**Request for Additional Information No.579, Supplement 1**

**U.S. EPR Standard Design Certification**

**Docket No. 52-020**

**Question 19-366:**

Figure 7.3-2—SIS Actuation

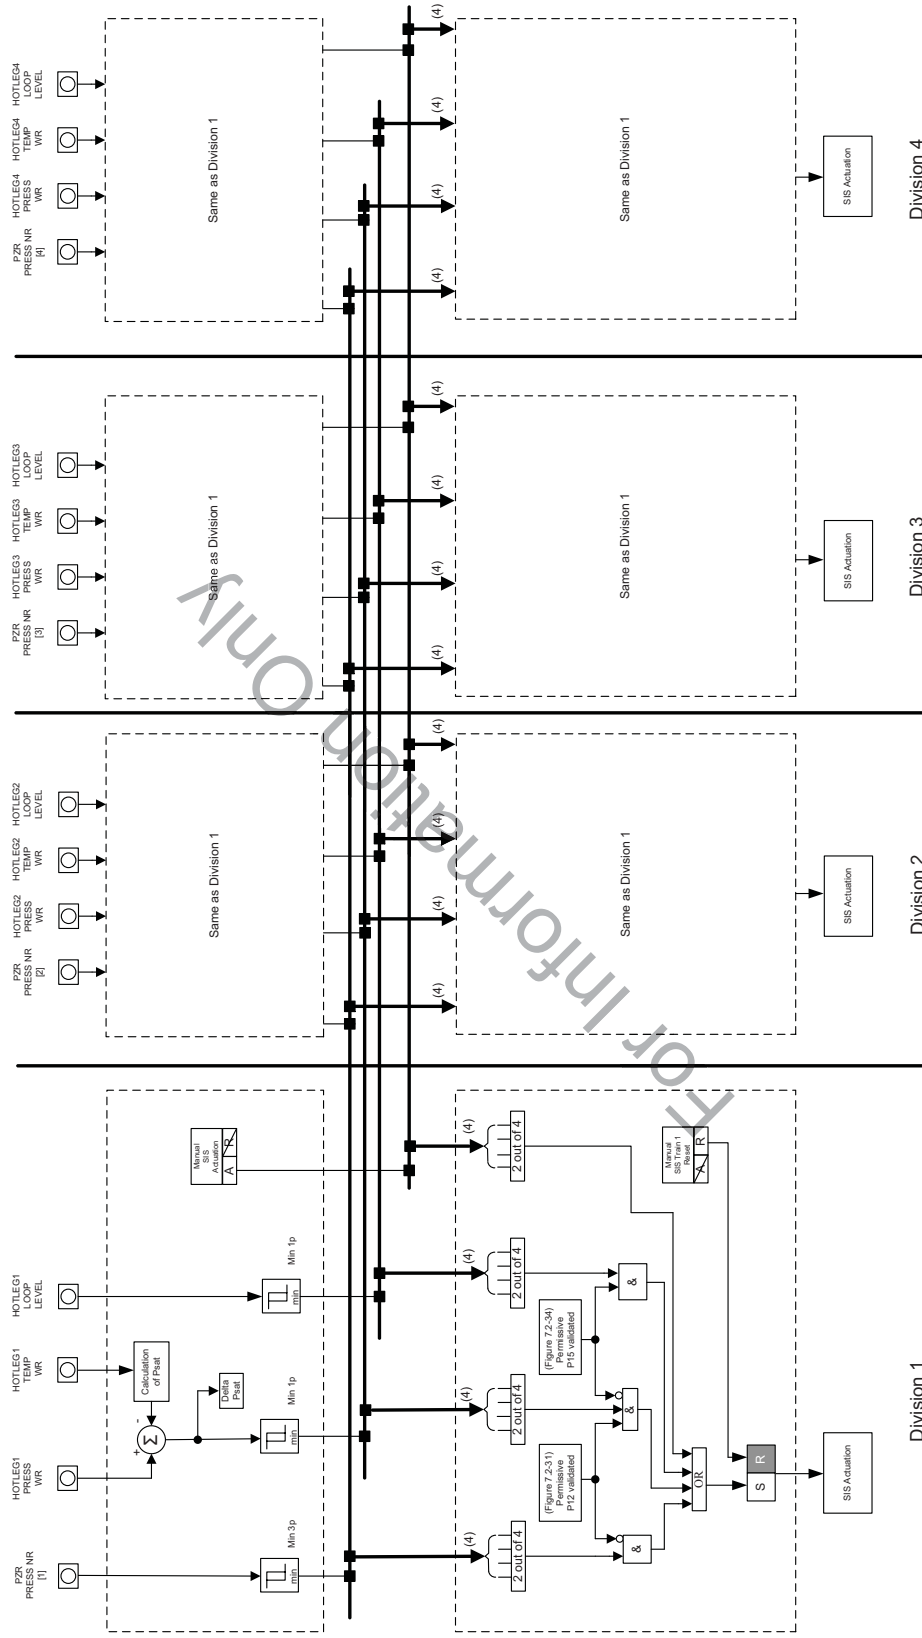
- U.S. EPR Tier 2 Figure 7.3-2 is revised to remove the bypass switch.
- U.S. EPR FSAR Tier 2 Section 7.3.2.1 is revised to remove discussion of the bypass switch.
- Technical Specification 3.3-2 and bases is modified to remove the bypass switch

(RCP) shut down. It is bypassed above the P15 thresholds. ~~A manual bypass of SIS actuation on low hot leg loop level is provided for protection of personnel working in the RCS components during outages.~~
